## **STONE HEDGE SUBDIVISION, UNIT 1, RESUBDIVISION OF LOT 40 & WEST COMMON AREA**

APPLICATION NUMBER 5 DATE June 7, 2018  
APPLICANT Stone Hedge Subdivision, Unit 1, Resubdivision of Lot 40 & West Common Area  
REQUEST Subdivision

# DETAIL SITE PLAN

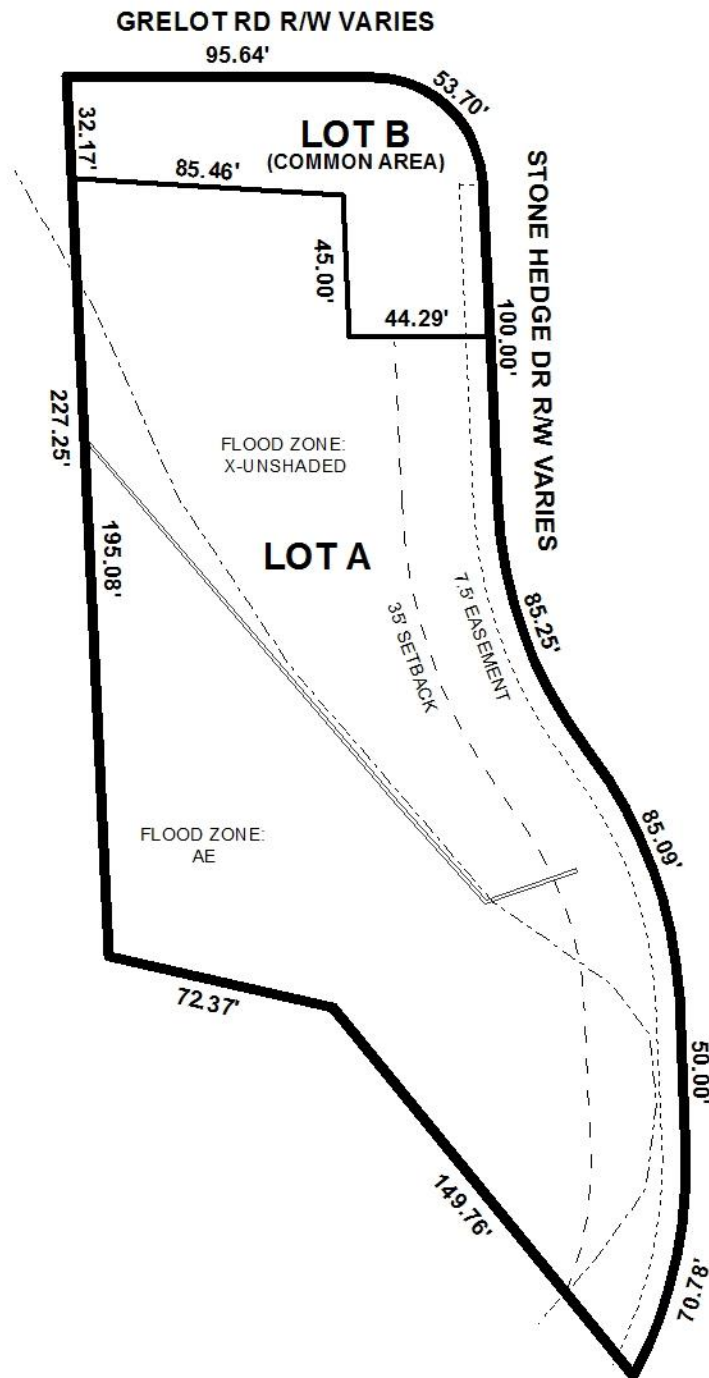
Proposed Lot A would meet the minimum size requirements of the Subdivision Regulations, but proposed Lot B would be of substandard size (6,346.9 square feet). However, as Lot B would still be a buffer strip/common area and not developable, its substandard size would be allowable. A note should be required on the Final Plat stating that Lot B is to remain a buffer strip/common area and may not be developed. The plat contains a table giving the size of each lot in both square feet and acres and this should be retained on the Final Plat, or the plat should be revised to label each lot with its size in both square feet and acres.

Lot A is currently developed with a residence and one curb cut to Stone Hedge Drive. A note should be required on the Final Plat limiting Lot A to its existing curb cut to Stone Hedge Drive. As Stone Hedge Subdivision was recorded with a 35' minimum building setback line along all street frontages, the Final Plat should retain that setback as shown on the preliminary plat.

A note should be required on the Final Plat stating that the maintenance of the buffer strip/common area is the responsibility of the subdivision property owners.

- 1) placement of a note on the Final Plat stating that Lot B is to remain a buffer strip/common area and may not be developed;
- 2) retention of the lot size table in both square feet and acres, or revision of the plat to label each lot with its size in both square feet and acres;

- 3) placement of a note on the Final Plat stating that Lot A is limited to its existing curb cut to Stone Hedge Drive;
- 4) retention of the 35' minimum building setback line along Stone Hedge Drive for Lot A;

- 5) placement of a note on the Final Plat stating that maintenance of the buffer strip/common area is the responsibility of the subdivision property owners;
